1:1000 scale - proposed parking restrictions
Mount Pleasant Road - Brixham

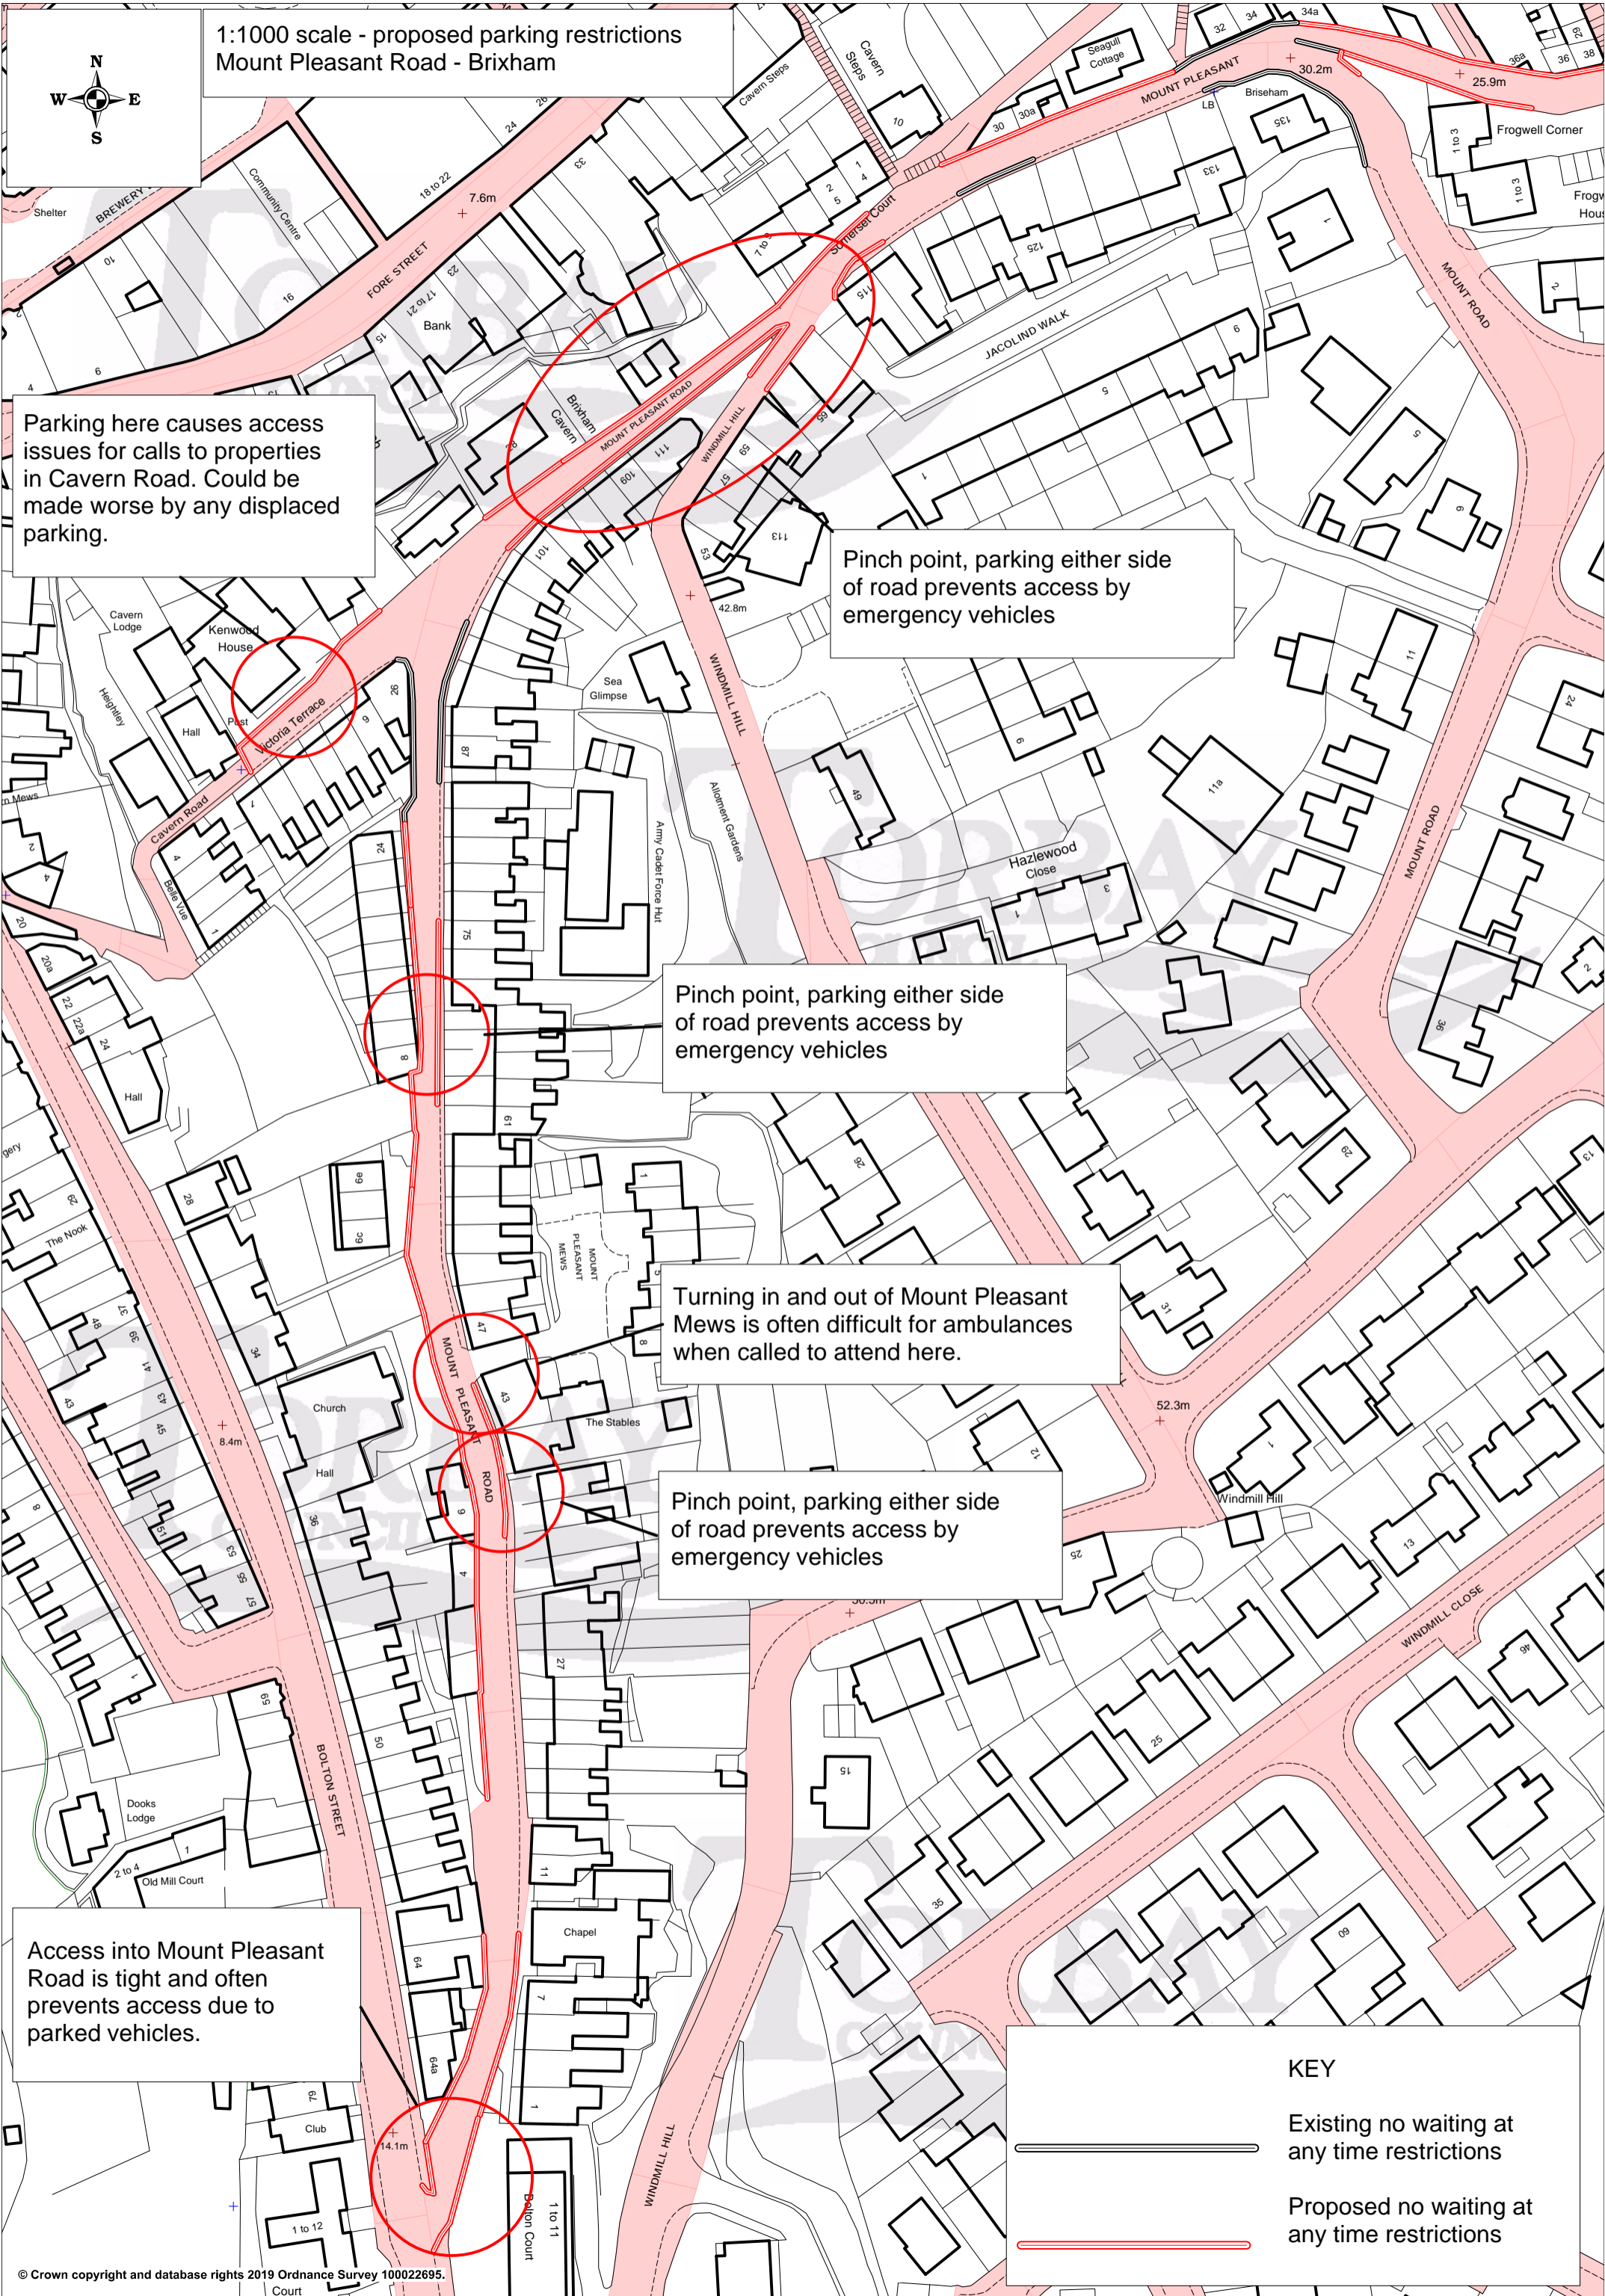
Parking here causes access issues for calls to properties in Cavern Road. Could be made worse by any displaced parking.

Pinch point, parking either side of road prevents access by emergency vehicles

Pinch point, parking either side of road prevents access by emergency vehicles

Turning in and out of Mount Pleasant Mews is often difficult for ambulances when called to attend here.

Pinch point, parking either side of road prevents access by emergency vehicles

Access into Mount Pleasant Road is tight and often prevents access due to parked vehicles.
